Office Action Summary

10/517,602

VAN PRAAG ET AL.

DETAILED ACTION

FIG. 2

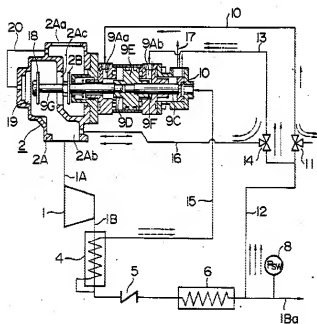
In regards to Independent **Claim 1**, and with particular reference to Figures 2, 3a, and 3b shown immediately above, **Suzuki (4,708,599)** discloses:

A compressor, containing a compressor element (1), and comprising a rotor chamber connected to an inlet pipe (1A) and an outlet pipe (1B); a reservoir in communication with the outlet pipe (1B); a pressure regulating system including an inlet valve (2) associated with the inlet pipe (1A); a piston (2B, 18) connected to the inlet valve (2) and which is movable in a cylinder (9F) to open and close the inlet valve (2) without the use of a spring acting on the piston (2B, 18); wherein the piston (2B, 18) is a double-acting piston which divides the cylinder (9F) into first (9Fa) and second (9Fb) closed cylinder chambers.....the first cylinder chamber (9Fa), on a first side of the piston (2B, 18) facing away from the inlet valve (2), is connected to a part of the rotor chamber located near the inlet valve (2) via a first pipe (15), wherein the connection is always open; and on a second side of the piston (2B, 18), the second cylinder chamber (9Fb) is connected to a part of the rotor chamber situated near the inlet valve (2) and to the non-return valve (5) via a second pipe (1A)

As shown in the figures above, Suzuki discloses a rotary compressor system that is designed to smoothly and surely operate a suction valve of a compressor inlet without the use of a spring acting upon the valve member (i.e. piston). In particular, Suzuki first states "In another type of rotary compressor apparatus, on the contrary, the suction throttle valve means is always urged by a spring to be closed. In this type of rotary compressor apparatus, the compressor is started at no load, however, it takes a long time to open the suction throttle valve means against the urging spring. It has been proposed to provide a separate pressure source for the suction throttle valve means.

Suzuki’s device therefore utilizes a double-acting piston (2B, 18) to provide proper loading and unloading conditions for the compressor (See Column 5, Line 32 - Column 7, Line 26) Also, Suzuki’s piston divides the cylinder into two separate closed cylinders. In particular, Suzuki states “The cylinder 9A incorporates therein a gas release valve element 9B for opening and closing the gas release opening 9Ac, a rod 9C provided at one end thereof with the valve element 9B, a rod 9D provided at one end thereof with the valve element 2B and an unloader piston 9E dividing a working chamber 9F into two chamber sections 9Fa and 9Fb. The other ends of the rods 9C and 9D are connected to the opposite ends of the piston 9E, respectively. The piston 9E is closely fitted to and movable within the cylinder 9A.” (Column 2, Lines 38-48) Lastly, Suzuki’s device utilizes an always-open (i.e. no valving) first pipe 15 that connects one of the chambers to the rotor chamber, as well as a second pipe 1A that connects the opposing chamber to the rotor chamber (See Figure 2). However, although Suzuki discloses the majority of Applicant’s claimed invention, it fails to substantially and specifically disclose Applicant’s bridge setup.

FIG. 1

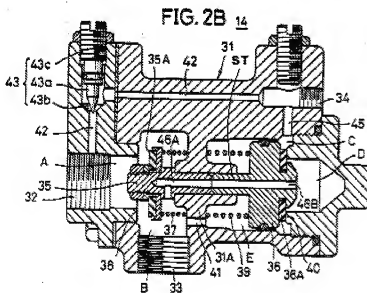
As seen in Figure 1 immediately above, UK Patent Application Publication to **Ott** (**GB 2,133,585**) teaches the remaining elements of Independent Claim 1 by disclosing a bridge bridging the inlet valve, a gas stream limiter, and a gas pipe. In particular, Ott discloses:

A bridge (12) bridging said inlet valve (4) and in which, between the inlet pipe (2) and the rotor chamber (1), are successively mounted a gas stream limiter (11) and a non-return valve (13) which only admits gas into the rotor chamber (1); a gas pipe (16) connecting the reservoir (9) to a part of the bridge (12) situated between the gas stream limiter (11) and the non-return valve (13); and a relief valve (14) associated with said gas pipe (16)

As can be seen in Figure 1 immediately above, Ott discloses an arrangement for controlling the loading and unloading of a screw compressor that is very similar to the system seen in Suzuki. Ott, however, further describes the piping arrangements and valve placements of the system that Suzuki fails to disclose. In particular, Ott discloses the use of a bypass line 12 (i.e. bridge) with a bypass valve 14 (i.e. relief valve) in order to properly throttle the amount of gas conveyed by the compressor. Ott goes on to

disclose "The throttle valve is by-passed by a by-pass line (12) with a by-pass valve (14), the passage cross-section of which can be adjusted in at least two stages, by means of a control device (15). For the starting process of the compressor (1), a larger passage cross-section can be opened and for idling, a smaller passage cross-section. In order to prevent the medium from flowing back through the by-pass line (12) against the suction direction, a check valve (13) is installed into the by-pass line (12)." (Abstract) Both of the above references deal with controlling the capacity and/or flow of the lubricant (or gas) within a compressor system. Consequently, one of ordinary skill in the art desiring more precise compressor control could have easily modified the piston of inlet valve of Suzuki with the bridge setup found in Ott in order to obtain such a result. Consequently, it would have been obvious to one of ordinary skill in the art of compressor capacity controls to modify the inlet valve setup of Suzuki with the bridge setup Ott in order to obtain predictable results; those results being a more accurate compressor control system that provides reliable control of the inlet valve without the need for a spring.

Figure A

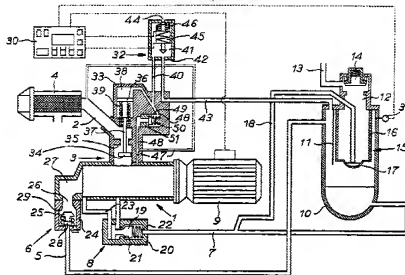
As shown in Figure A immediately above, the Coppens portion of the combination specifically discloses the specific use of electromagnetics for the control valve 32. It would have been obvious to one of skill in the art to utilize the techniques disclosed in the Suzuki-Ott combination in combination with those seen in the Coppens reference in order to obtain predictable results. One of ordinary skill in the art at the time of the invention could have easily applied the electromagnetic valving techniques of Coppens to the control valve of Ott in order to obtain predictable results; those results being a more reliable and better-controlled compressor system.
